FCC ID: L76-BT190I

Subject: Request Class II Permissive Change for FCC ID: L76-BT190I

A permissive change is requested for the subject transceiver which is marketed in the United States and elsewhere as the Koss Corporation's Bluetooth Headset.

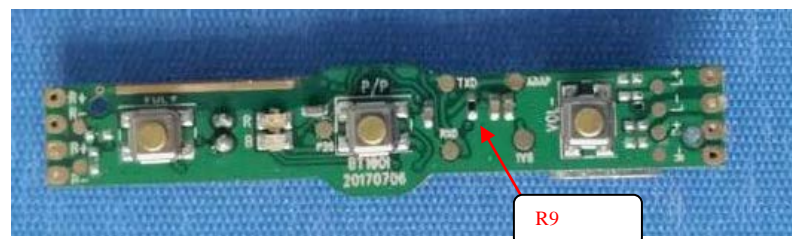
1. Three plastic buttons are changed to metal buttons (SW1, SW2, SW3);
2. External photos not change;
3. PCB Layout changed, only change PCB shape and routing, the R9 resistor's position moved from the bottom of the original PCB to the top of the new PCB, please see the photo.
